Accepted submission of drainage proposal of the Previous Application

Submission for Compliance with Approval Condition (f) – The Submission of a Drainage Proposal

Proposed Temporary Animal Boarding Establishment for a Period of 5 Years and Filling of Land in “Agriculture” (“AGR”) Zone, Lot 1185 S.E RP in D.D. 106 and Adjoining Government Land, Kam Tin, Yuen Long (Application No. A/YL-KTS/919)

**Proposed Temporary Animal Boarding Establishment
for a Period of 5 Years and Filling of Land
Lots 1185 S.E RP in D.D. 106,
Kam Tin, Yuen Long, New Territories**

參考編號 REFERENCE No. A/YL-KTS/919	PROPOSED DRAINAGE PLAN
---------------------------------------	---------------------------

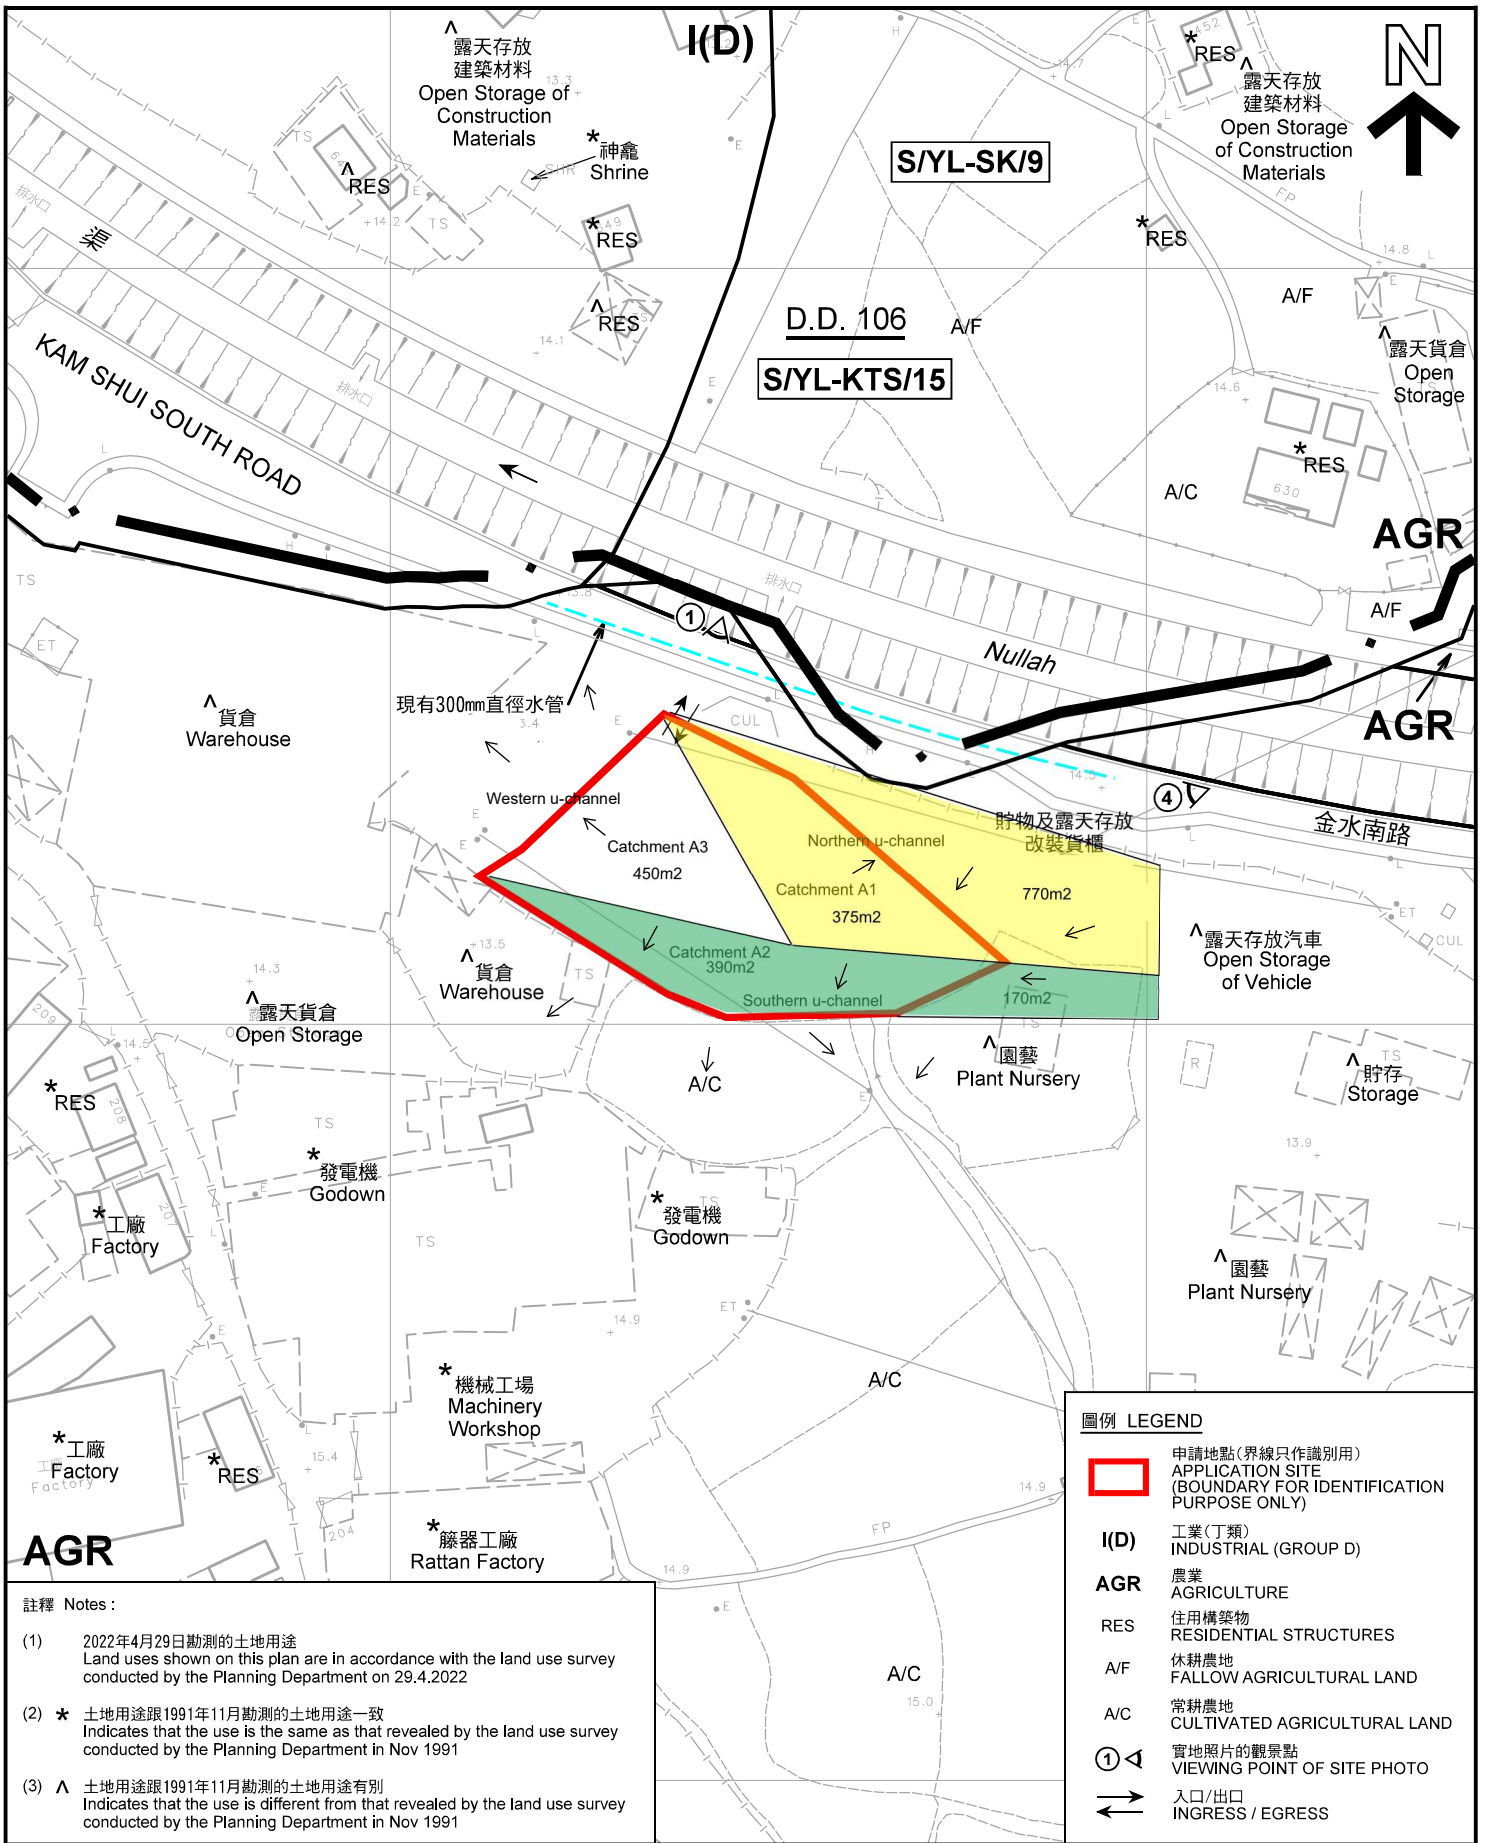
Further Comments from DSD	Response
1. The cover levels of the proposed catchpits/sand traps should be shown on the drainage plan.	Noted. The cover levels of the proposed catchpits/sand traps are shown on the revised drainage plan.

2. Referring to the cross sections provided, the ground to the east and south of the application site is generally higher. Since the overland flow from the adjacent lands shall be probably intercepted, external catchments should be considered in the calculations.	Noted. The revised calculation has taken the adjacent grounds to the east and south of the application site into account. As shown in the enclosed design calculation, the usages of the northern, southern and western u-channels are 75%, 36.7% and 30% respectively. The usage of the outlet 600mm dia. pipe is only 21.1%. The proposed drainage arrangement has sufficient capacity to cater for the flows.

3. The proposal should indicate how the runoff (the flow direction) within the site would be discharged to the proposed u-channel.	Some proposed site levels and flow directions are added on the revised drainage plan. In addition, it is proposed to construct a short section (about 0.5m) of 600mm diameter concrete pipe protruding from the proposed sand trap for the installation of the proposed flap valve.

DRAWING TITLE
FIRE SERVICE INSTALLATION LAYOUT PLAN

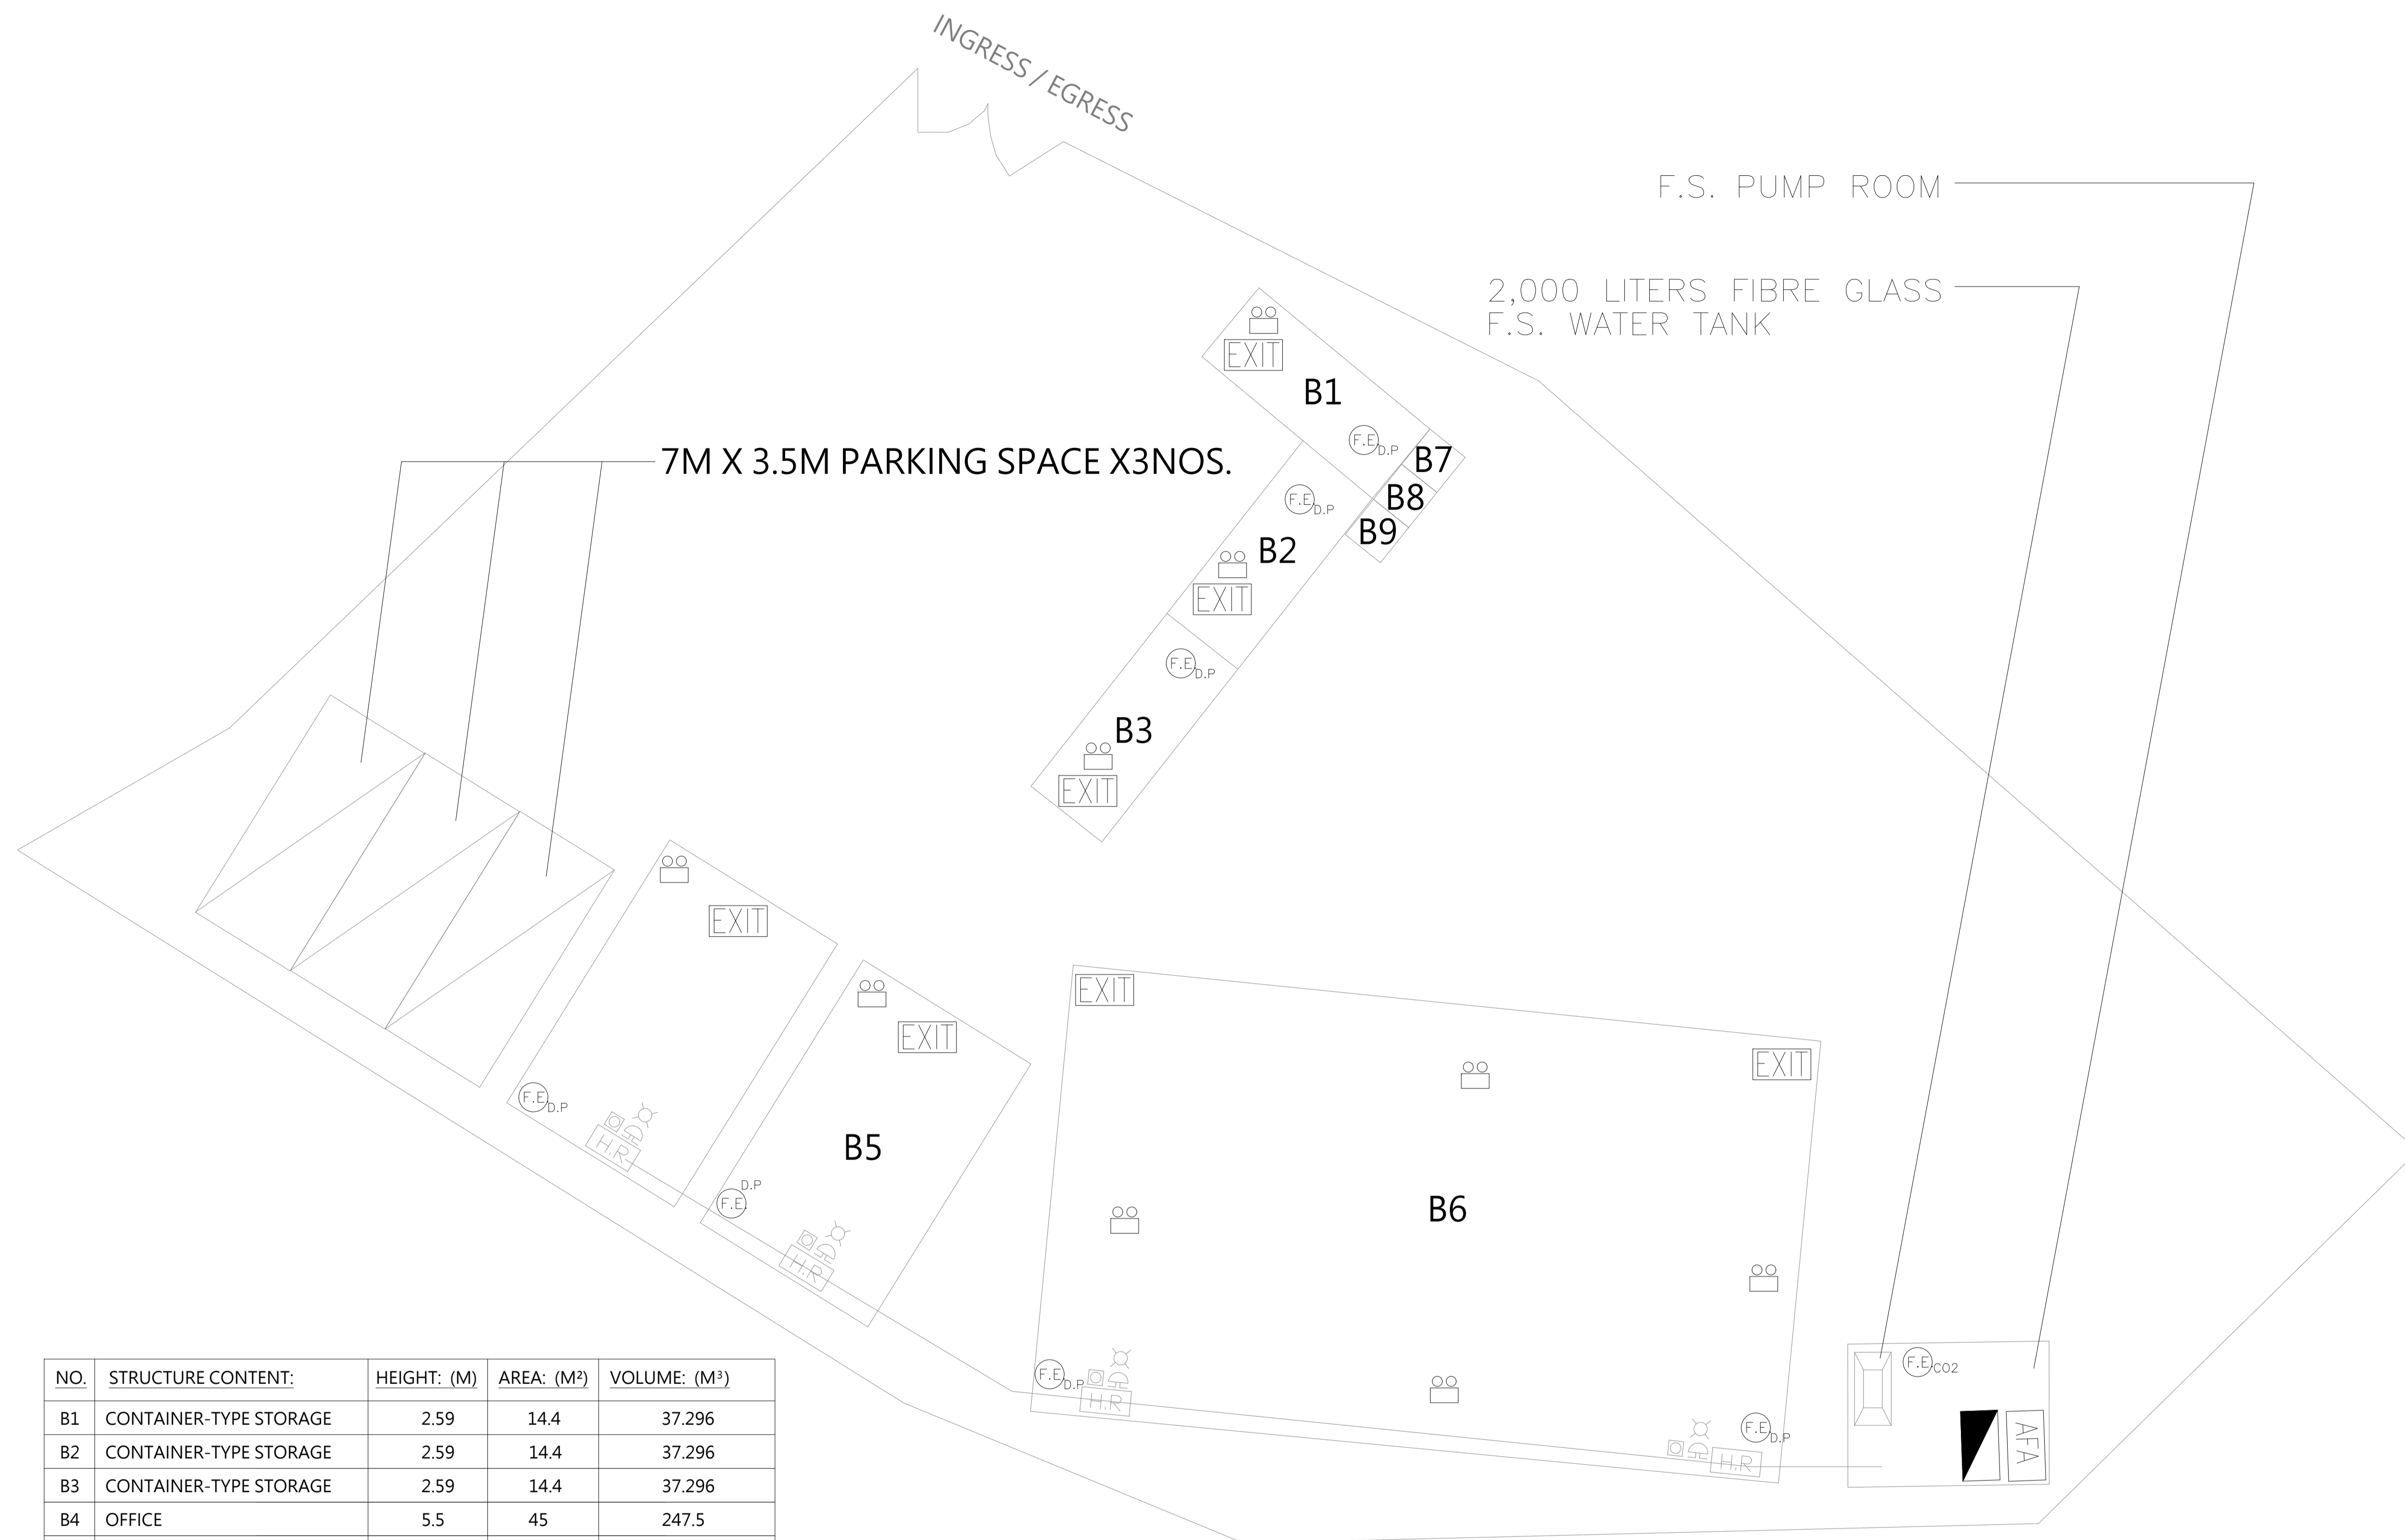
- (i) Structures on the same site are regarded as adjoining structures if they are less than 1.8m apart. In this regard, sprinkler system, modified hose reel system and fire alarm system shall be provided to Structures B4 and B5;
- (ii) "fixed fire pumps" as mentioned in FS Notes item 2.5 shall be revised as "sprinkler pumps";
- (iii) "cubic meters" as mentioned in FS Notes item 6.4 shall be revised as "square meters";
and
- (iv) Regarding FS Notes item 3.3, please clarify if fire detection system will be provided to all structures except Structure B6.
